**SUBJECT: MEETING WITH ENTERGY OPERATIONS, INC. (ENTERGY), ON LICENSE RENEWAL FIRE PROTECTION SCOPING FOR ARKANSAS NUCLEAR ONE (ANO), UNIT 1**

# ANO-1 License Renewal

Fire Protection Open Item

- ◆ Open Item 2.2.3.3.2.2-1 of ANO-1 SER requested Entergy Operations provide sufficient justification for the exclusion of certain fire protection components from the scope of license renewal

FIGURE 60.02: FIRE WATER PUMPS

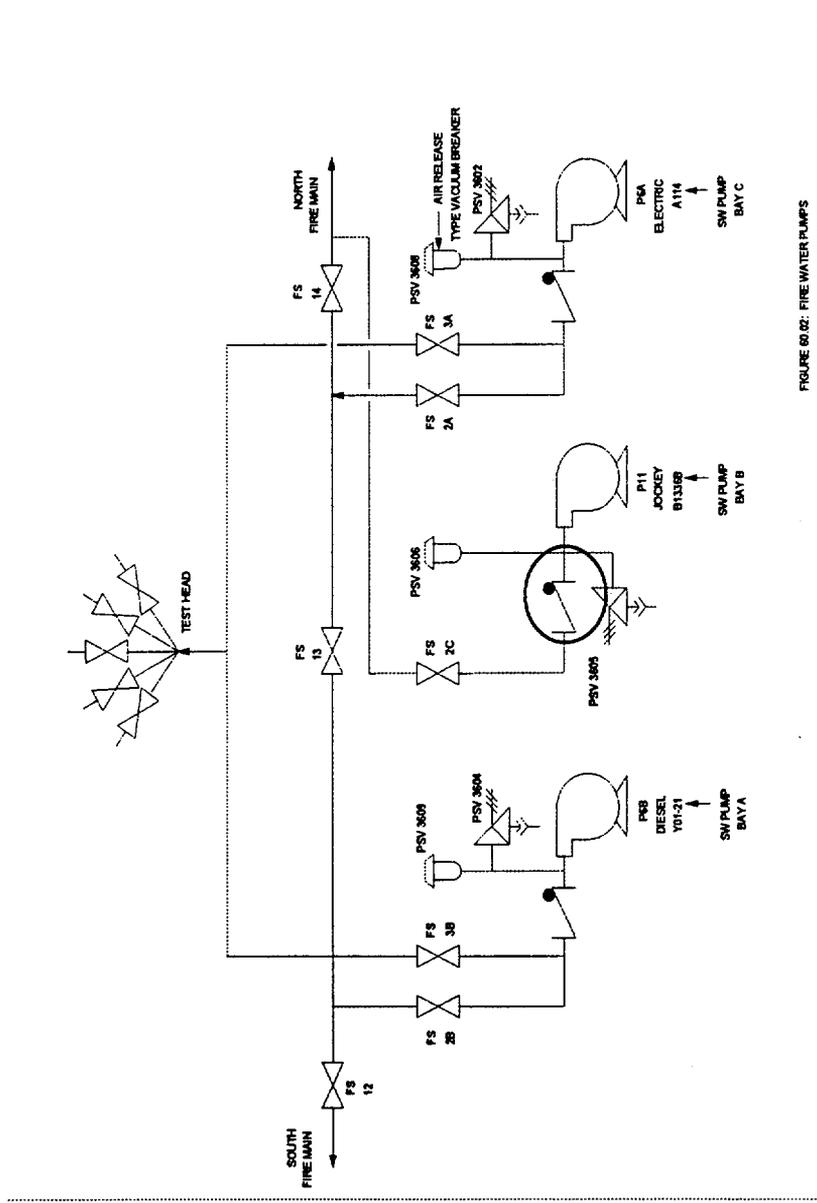
- ◆ Maintains fire main pressure when there is no demand on system
- ◆ Per BTP APSCB 9.5-1, “Details of fire pump installation should as a minimum conform to NFPA 20”
- ◆ Not a required component per NFPA 20 “Standard for the Installation of Stationary Pumps for Fire Protection”

- ◆ 1978 SER, Evaluation of plant features:
  - ◆ “Two vertical shaft centrifugal fire pumps are provided...”
  - ◆ “An automatic electric jockey pump maintains pressure on the fire piping system.”
- ◆ 1978 SER, Conclusion:
  - ◆ “We find that the fire pumps conform to the provisions of Appendix A to BTP 9.5-1 and are, therefore acceptable.”

**Jockey Pump:** ANO stated that the jockey pump is not required for safe shutdown under its current licensing basis and therefore is not within the scope of license renewal.
